Title - Sujet Palace Grand Theatre Foundation Rep	
Solicitation No. - N° de l'invitation EZ899-152418/A	Amendment No. - N° modif. 005
Client Reference No. - N° de référence du client	Date 2015-07-03
GETS Reference No. - N° de référence de SEAG PW-\$PWY-022-7522	
File No. - N° de dossier PWY-5-38030 (022)	CCC No./N° CCC - FMS No./N° VME
Solicitation Closes - L'invitation prend fin at - à 02:00 PM on - le 2015-07-10	Time Zone Fuseau horaire Pacific Daylight Saving Time PDT
F.O.B. - F.A.B. Plant-Usine: <input type="checkbox"/> Destination: <input checked="" type="checkbox"/> Other-Autre: <input type="checkbox"/>	
Address Enquiries to: - Adresser toutes questions à: Arthur (PWY), Carolyn	Buyer Id - Id de l'acheteur pwy022
Telephone No. - N° de téléphone (604) 775-6667 ()	FAX No. - N° de FAX (604) 775-6633
Destination - of Goods, Services, and Construction: Destination - des biens, services et construction: Parks Canada - Palace Grand Theatre - Dawson City, YT

Palace Grand Theatre Foundation Replacement
Palace Grand Theatre, Dawson City, YT

Project Description: Palace Grand Theatre Foundation Replacement, Dawson City, Yukon

STRUCTURAL ADDENDUM

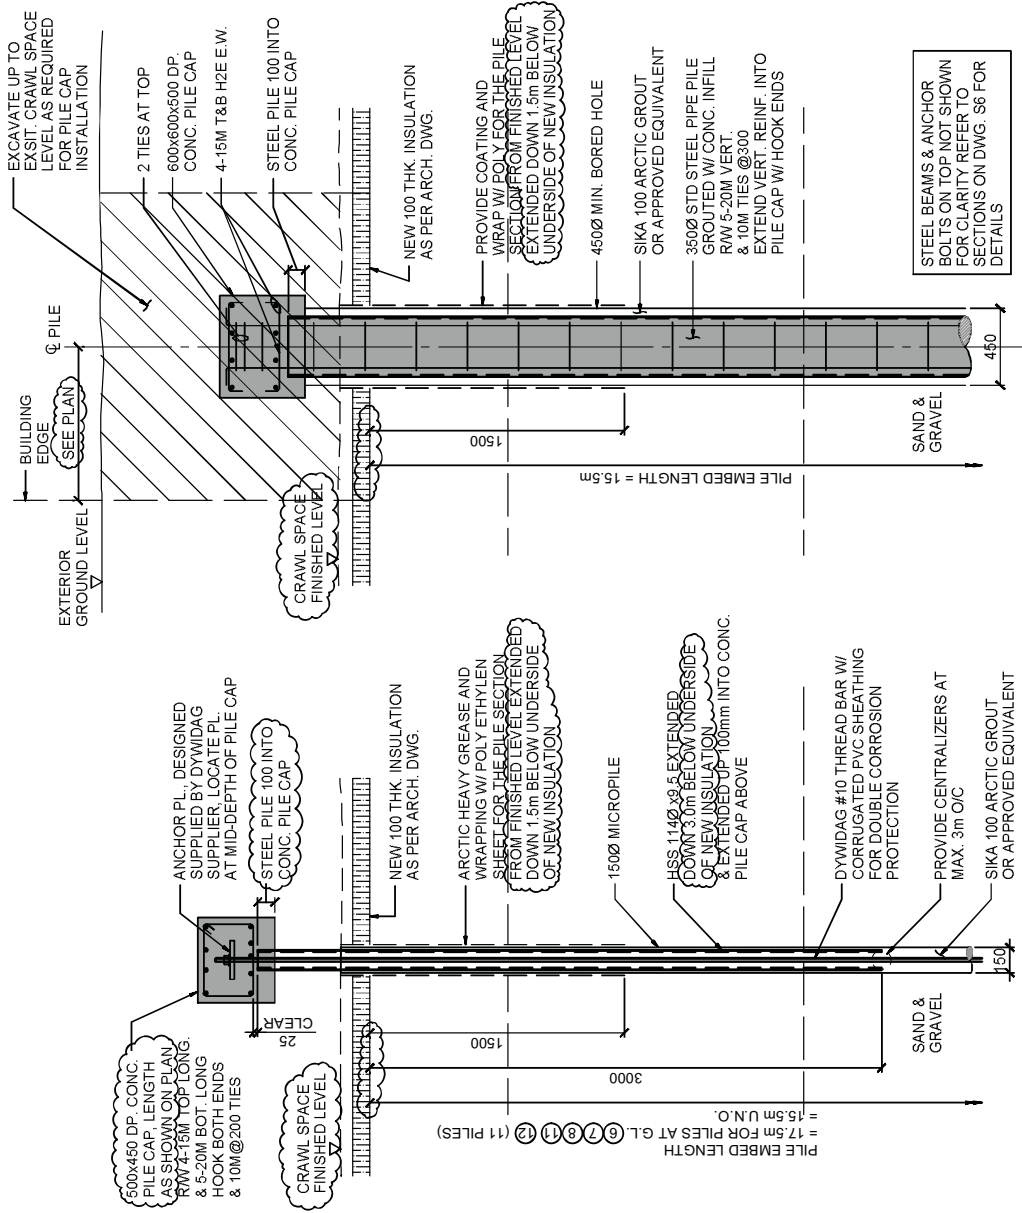
1. **Clarify** that the pile embedment depth, HSS extension and the coating & poly wrap shown on the typical pile details is measured from the underside of 100mm thick new insulation under the crawl space finished floor level and others as shown on the attached addendum sketch AD-S01.
